knitter-switch

Product-Change Notification

Products affected: KTT 107
KTT 204, KTT 206, KTT 208, KTT 209, KTT 217, KTT 227

Effective date: from date-code 1237 (week 37, 2012)

KTT 1xx

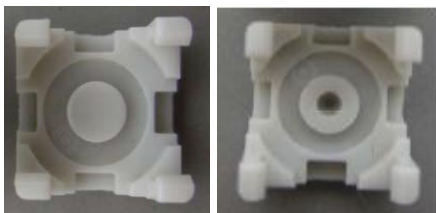
Due to a change of tolerances on assigned switches (TMP-series) the caps needed to be modified in the same way. The dimension 2.8 mm changes to 3.05 mm:

For easy visual identification of old and new version, the new caps have a 1.3 mm hole inside:
